SERVICE BULLETIN

N° **139-763**

**ATA 32 - MAIN LANDING GEAR SHIM INSTALLATION**

This Service Bulletin is issued in order to provide the necessary instruction on how to perform the MLG INSTL retromod for gap P/N 3G3200P00411.

**Figure 1**

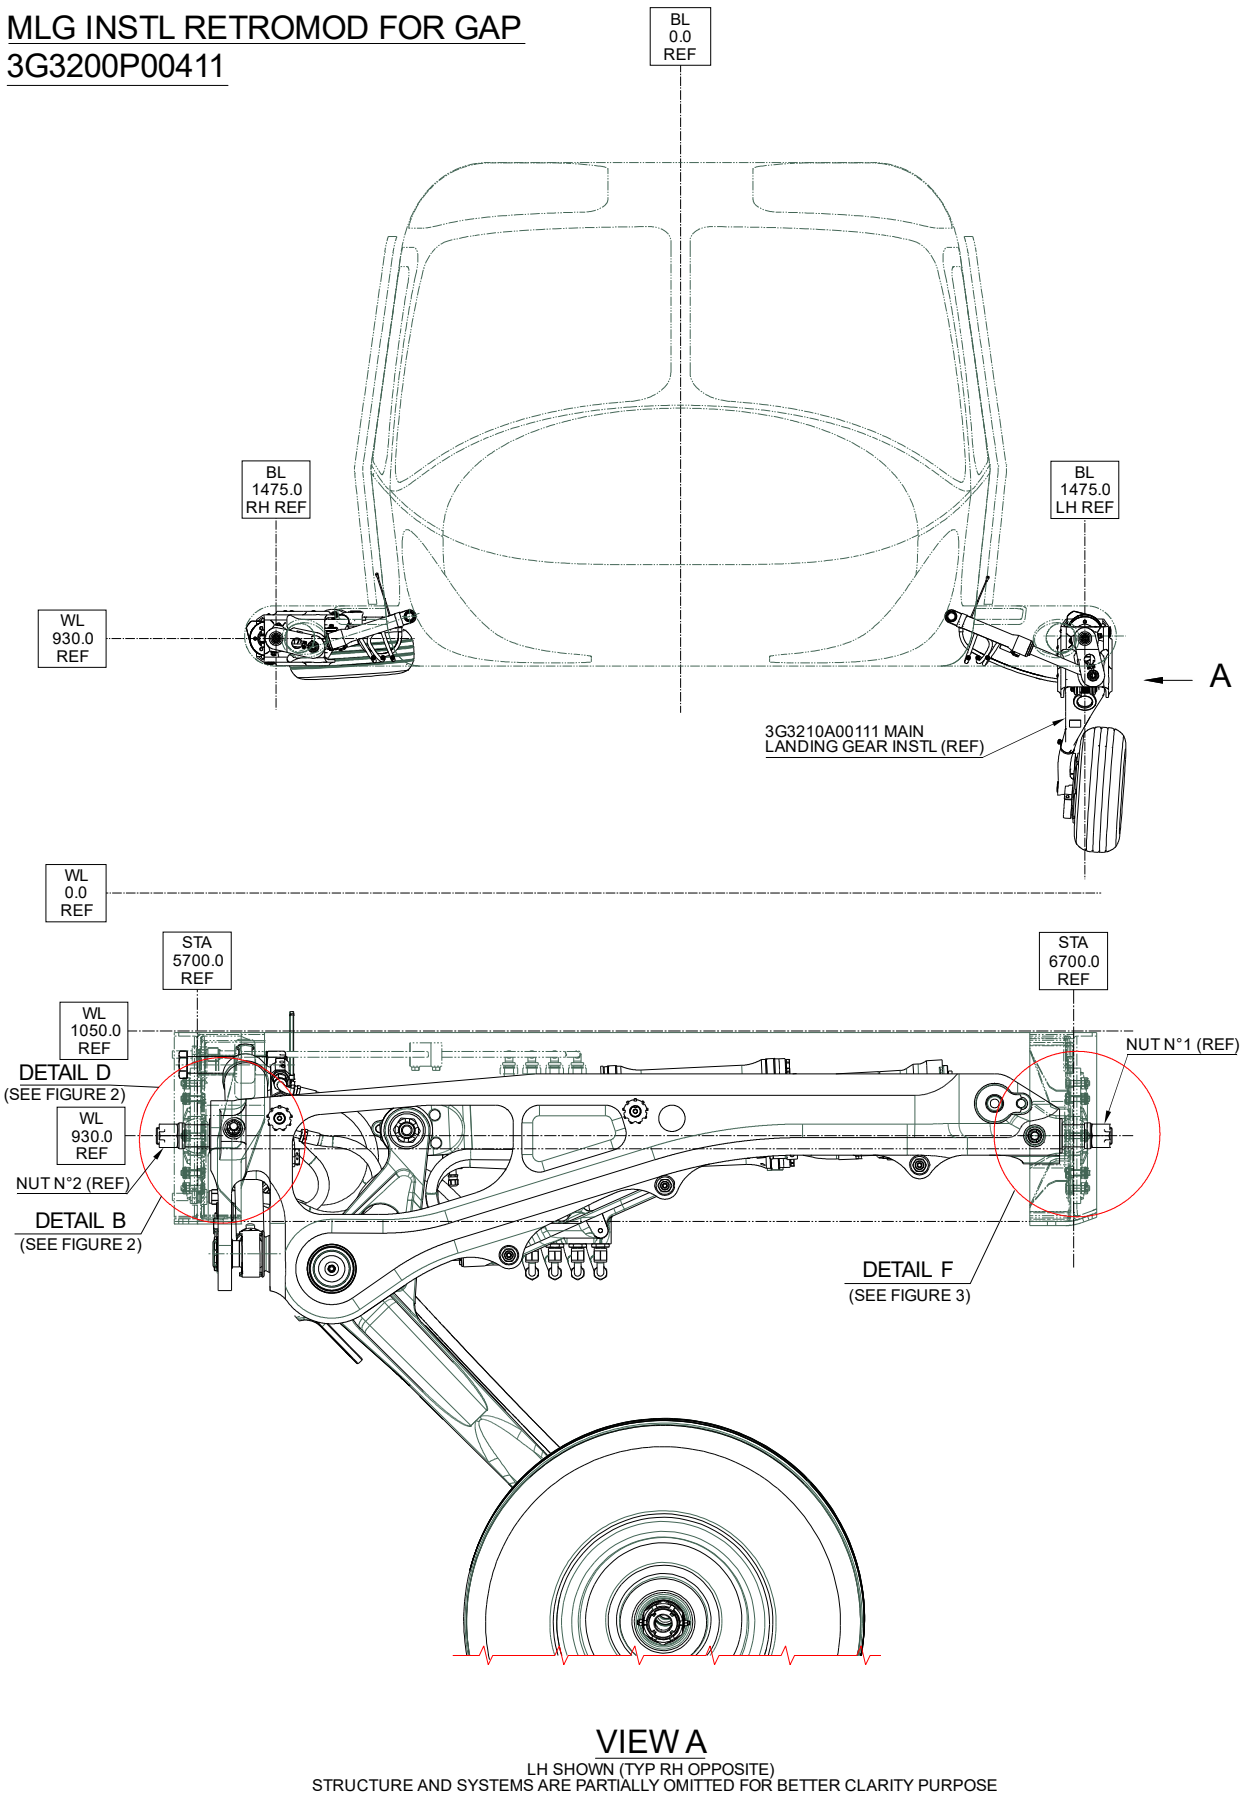
2. In accordance with AMP DM 39-A-06-41-00-00A-010A-A and with reference to Figures 1 thru 3, remove all external panels, internal panels and internal liners as required to gain access to the area affected by the installation and perform the MLG installation retromod for gap P/N 3G3200P00411 as described in the following procedure:
  - 2.1 Gain access to the MLG LH side.
  - 2.2 With reference to Figure 2 Detail B, remove and retain for later reuse the pintle pin P/N 1651-0001, the sleeve P/N 1651-0005 and the nut P/N MS17825-12. Remove and discard the cotter pin P/N MS24665-372.
  - 2.3 With reference to Figure 2 Section C-C, remove and retain for later reuse the screw P/N NAS6606D62, the washer P/N NAS1149C0632R and the nut P/N MS17825-6. Remove and discard the cotter pin P/N MS24665-300.

Figure 2

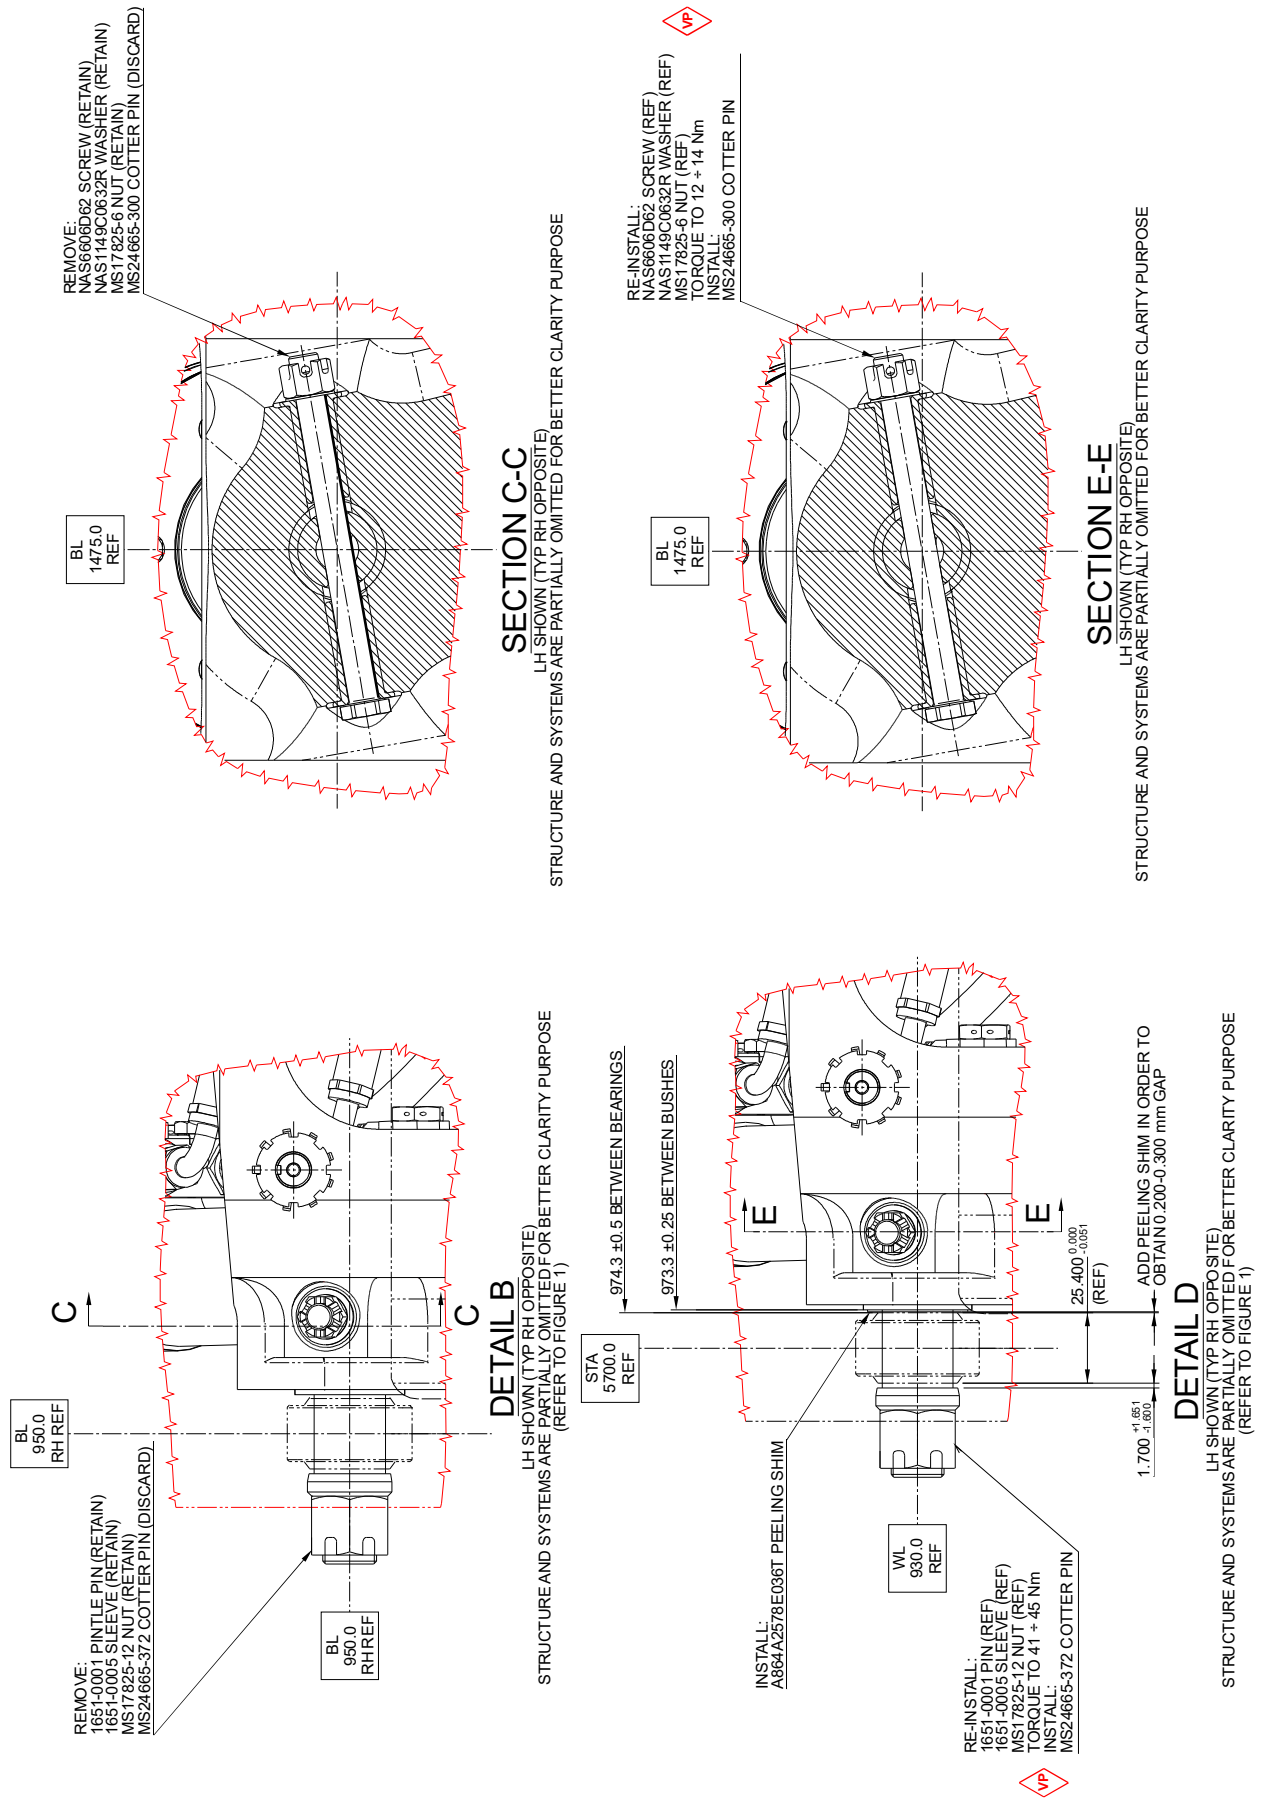
Add the peeling shim in accordance with the dimensions shown, in order to obtain the gap indicated in Figure.

- 2.4 With reference to Figure 2 Detail D, install the peeling shim P/N A864A2578E036T and re-install the pin P/N 1651-0001, the sleeve P/N 1651-0005 and the nut P/N MS17825-12 previously retained. Protect fasteners with polyurethane paint, using Tectyl 891D.
- 2.5 With reference to Figure 2 Detail D, tighten the nut previously installed to the torque value of 41.0÷45.0 Nm and install the cotter pin P/N MS24665-372 to safety the nut.

- 2.6 With reference to Figure 2 Section E-E, re-install the screw P/N NAS6606D62, the washer P/N NAS1149C0632R and the nut P/N MS17825-6 previously retained. Protect fasteners with polyurethane paint, using Tectyl 891D.
- 2.7 With reference to Figure 2 Section E-E, tighten the nut previously installed to the torque value of 12.0÷14.0 Nm and install the cotter pin P/N MS24665-300 to safety the nut.
- 2.8 Repeat steps from 2.1 to 2.7 for the MLG RH side.
3. In accordance with AMP DM 39-A-06-41-00-00A-010A-A, re-install all external panels, internal panels and internal liners previously removed.
4. Return the helicopter to flight configuration and record for compliance with this Service Bulletin on the helicopter logbook.
5. Gain access to My Communications section on Leonardo WebPortal and compile the "Service Bulletin Application Communication".

Wet assemble fixing fasteners using Sealant (C354) applied under the head of fasteners.

**Figure 3**

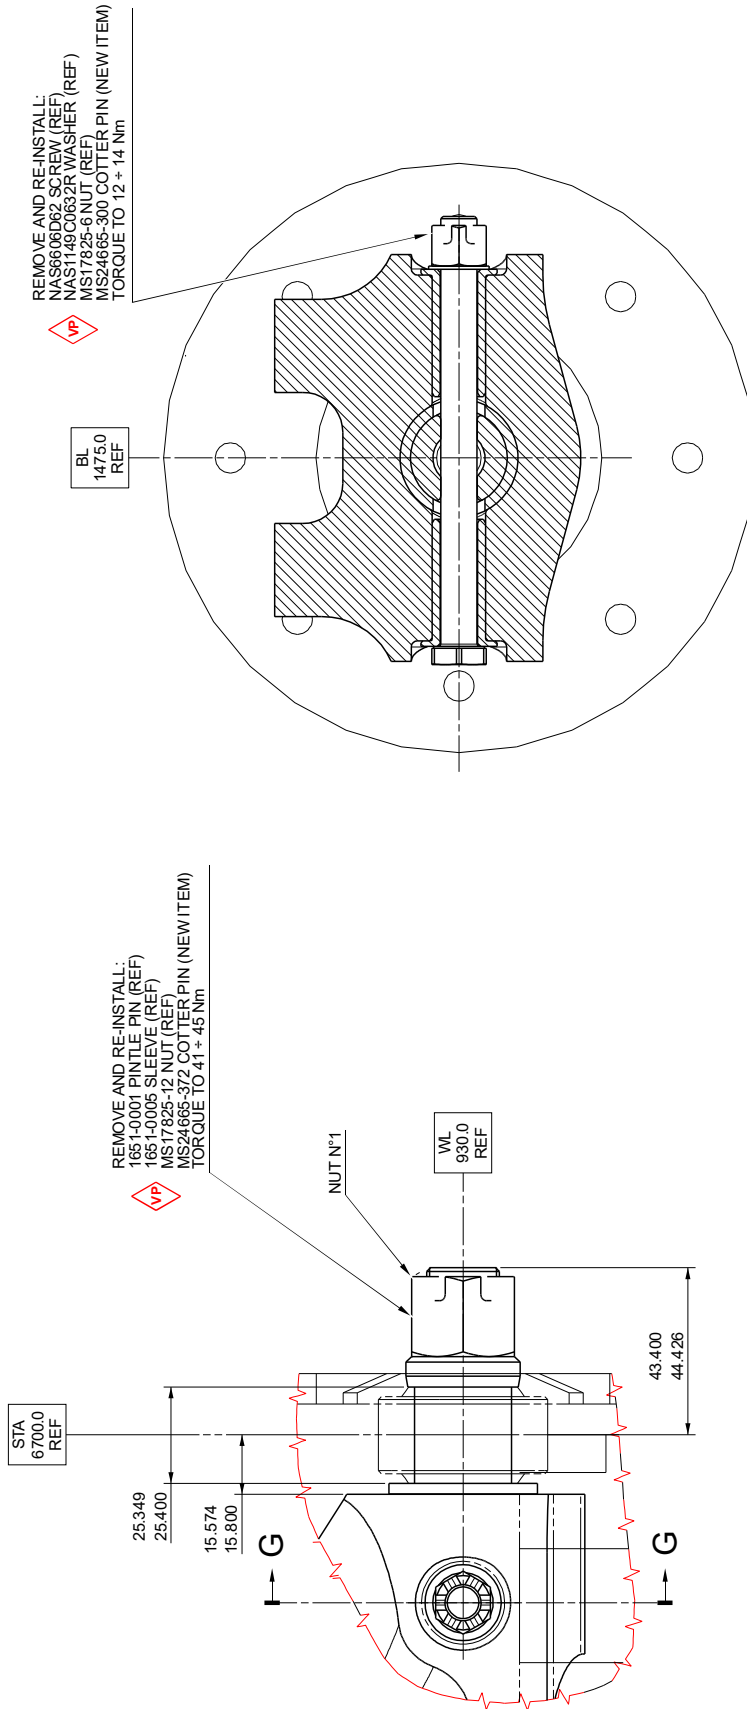
If necessary to operate to the nut N°1, remove and after the operations re-install all the fasteners indicated in Figure 3. During the installation operations, torque before the nut N°1 (BWD) and then the nut N°2 (FWD).
